Preliminary Consultation
MONTGOMERY COUNTY HISTORIC PRESERVATION COMMISSION
STAFF REPORT

Address:	11 Quincy St., Chevy Chase	Meeting Date:	1/8/2025
Resource:	Non-Contributing Resource Chevy Chase Village Historic District	Report Date:	12/31/2024
Applicant:	Malcolm & Kelly Little (Henry Chuang, Architect)	Public Notice:	12/25/2024
Review:	Preliminary Consultation	Staff:	Dan Bruechert
Proposal:	Demolition of existing house and construction of new single family house

Figure 3: Rendering of the proposed house.

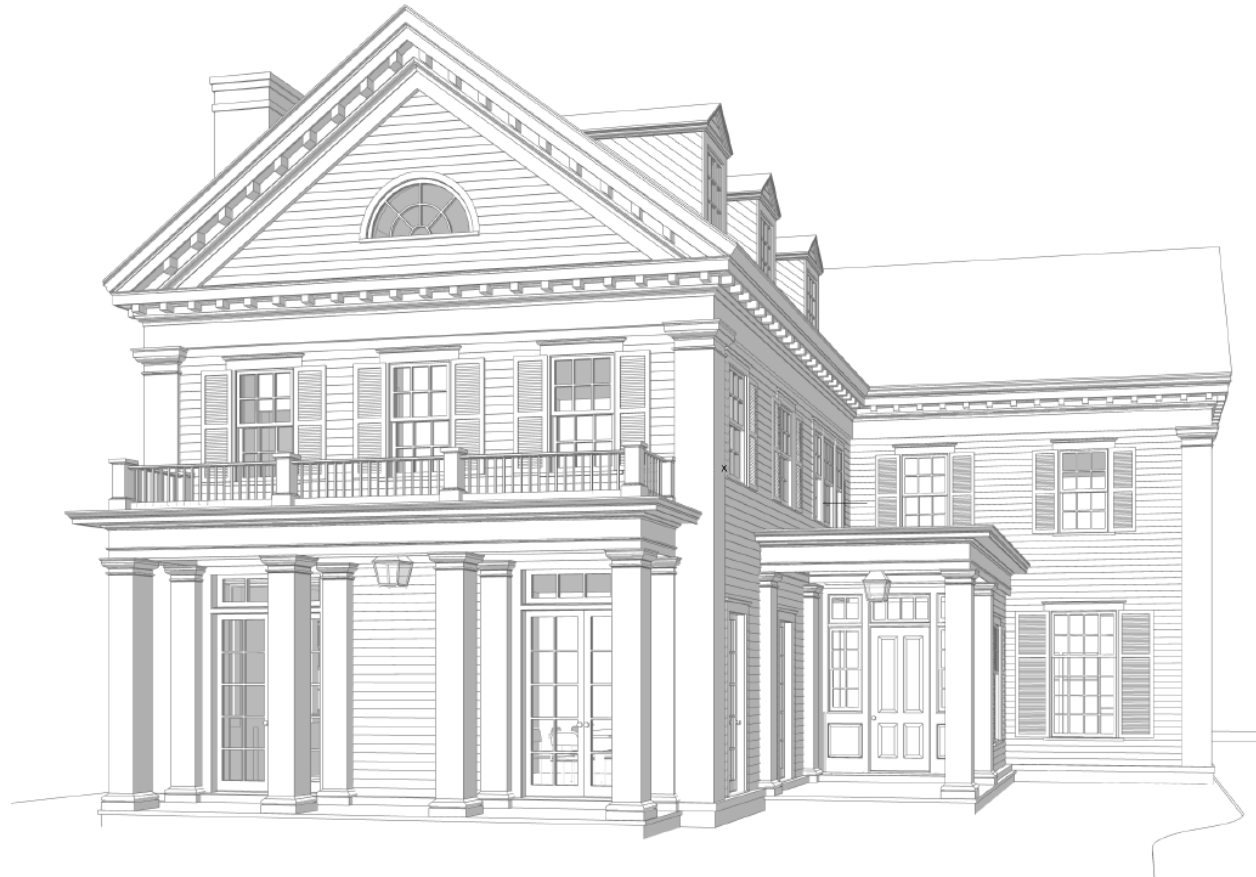
Staff finds the proposed house design and form are generally compatible with the character of the surrounding district. Staff finds the proposed form is similar to a house located at 5914 Cedar Parkway, located at the west end of the historic district, that was constructed in 1923 (see *Figure 4*, below). Furthermore, Staff finds the individual architectural elements including square columns, heavy cornice, dormers, and multi-light sash windows are all found on houses throughout the Chevy Chase Village Historic District.

In analyzing the size and mass of the house, Staff found that much more information is needed before coming to a conclusion. First, there are no dimensions on the drawings, so while interior heights identified, the overall height, width, and depth were not. Because the primary consideration with new construction is being “sympathetic to the traditional street and building patterns in the district,” an understanding of the characteristics of the adjacent streetscape is necessary. A streetscape study is an effective tool in completing this analysis. Staff recommends that the HPC request that a streetscape study be included with any subsequent submission(s). This information may be more vital because the house form includes a nearly three-story tall wall plane at the front of the house, rather than a more gradual rise in the side gable or hipped-roof house on the streetscape

Staff finds the proposed materials are all compatible with the character of the district and are found on the Contributing and Outstanding resources throughout the district. Additional information about the materials for the siding, columns, and shutters is needed to complete a thorough evaluation. However, Staff finds that wood is the most appropriate material for each of these features and requests feedback from the HPC on the whether a substitute material would be acceptable for any of these features while remaining consistent with the district’s “tradition of architectural excellence.”

Staff recommended the applicant supply the following additional materials for all subsequent submissions:

- Streetscape study;
- Notated plans that include dimensions, setbacks, and lot coverage calculations;
- Information on any grading, site alterations, and new hardscape;
- Complete specification packet (for the HAWP) or more specific info on proposed materials (for a

- 2nd Prelim); and,
- Report detailing any tree removals.

Existing Site Plan
 Scale: 1" = 20'
 Little Residence
 11 Quincy Street

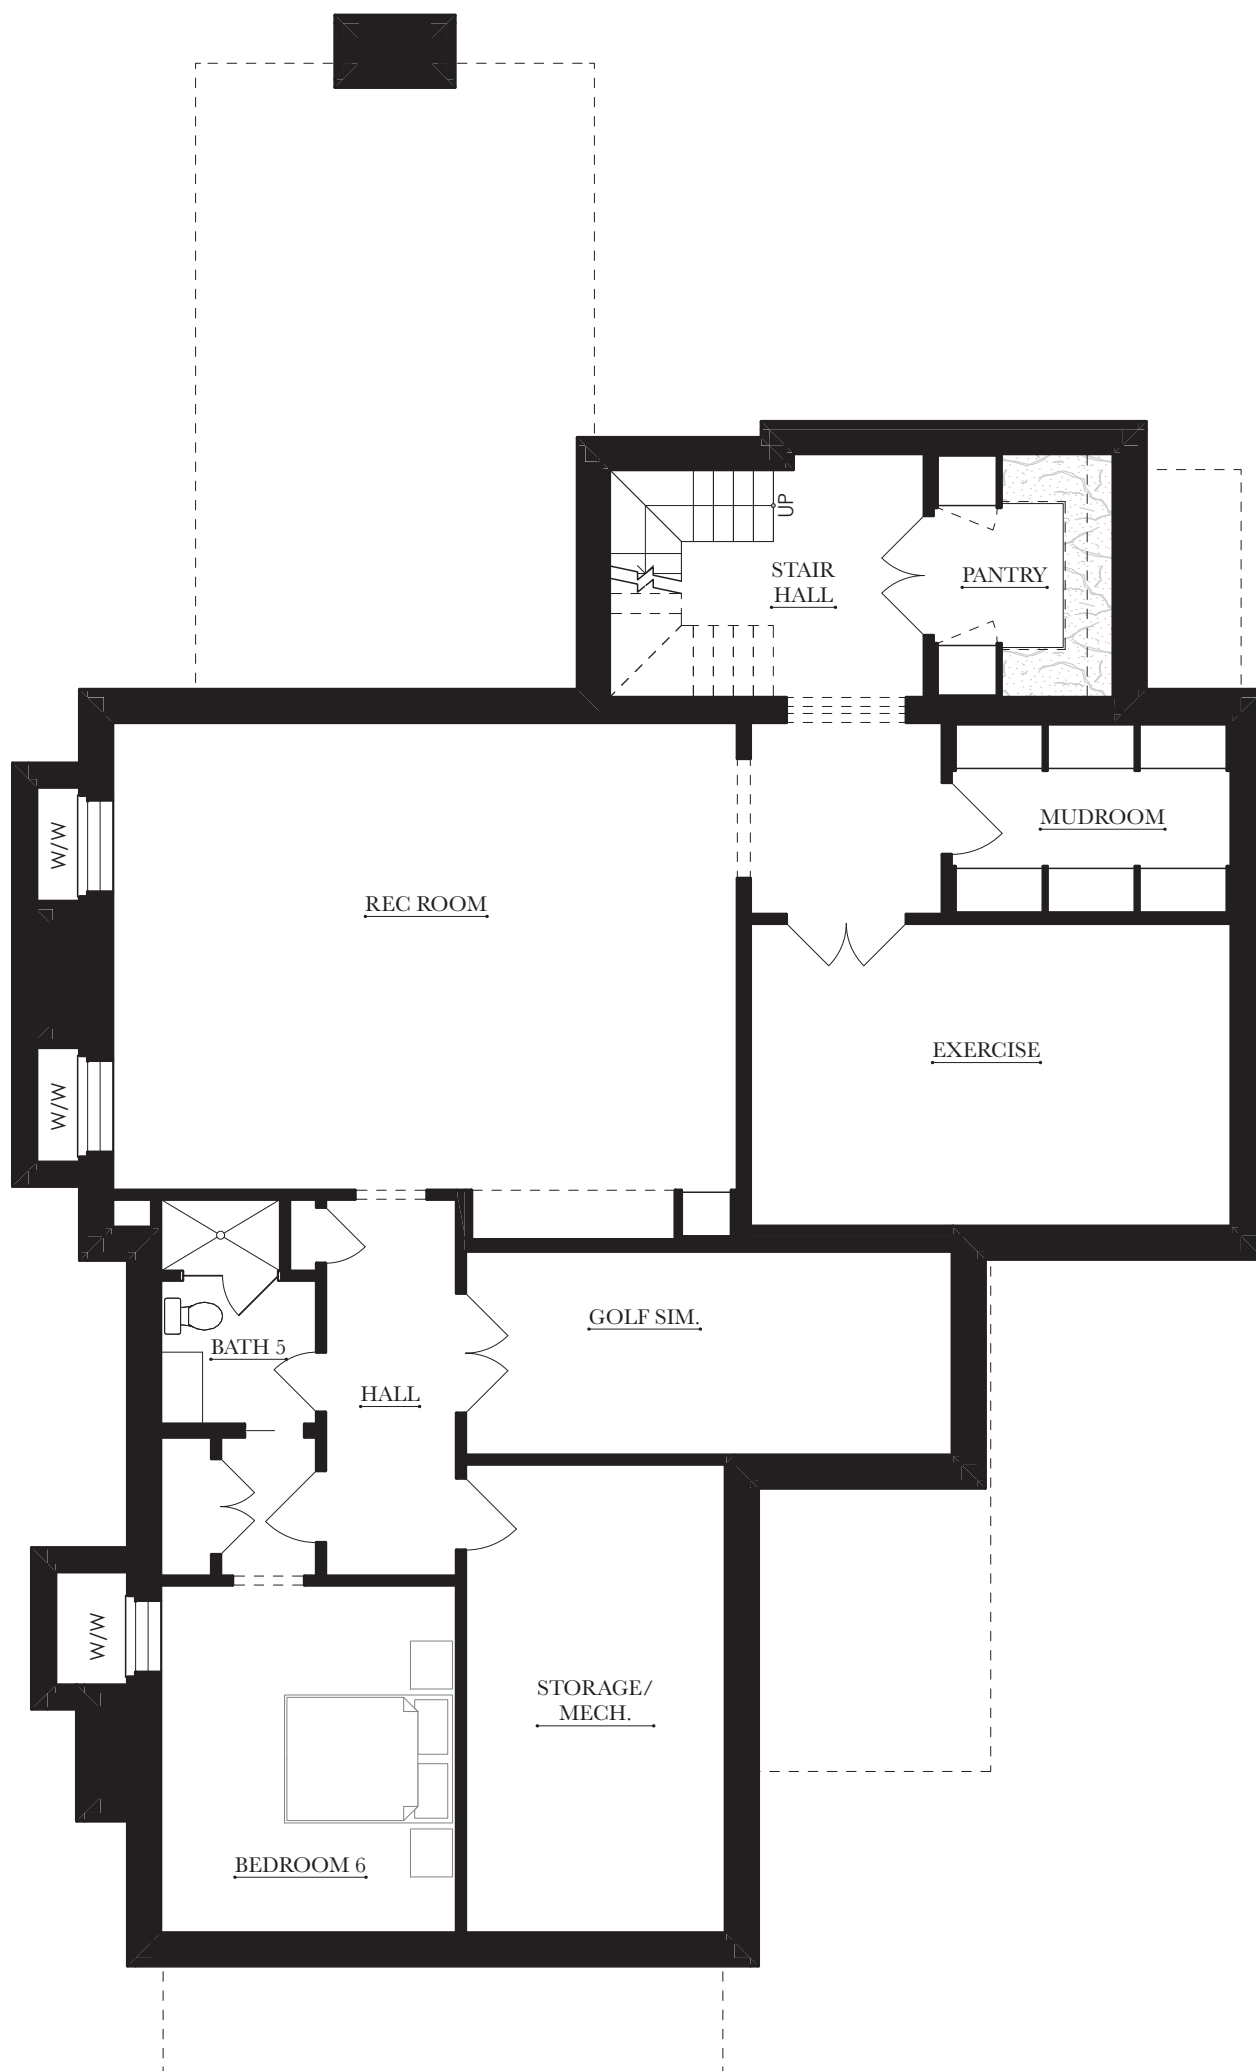
The front wall plane of the proposed house appears to be located approximately 5' (five feet) further to the rear than the existing house. The setbacks and overall dimensions should be provided with the next submission.
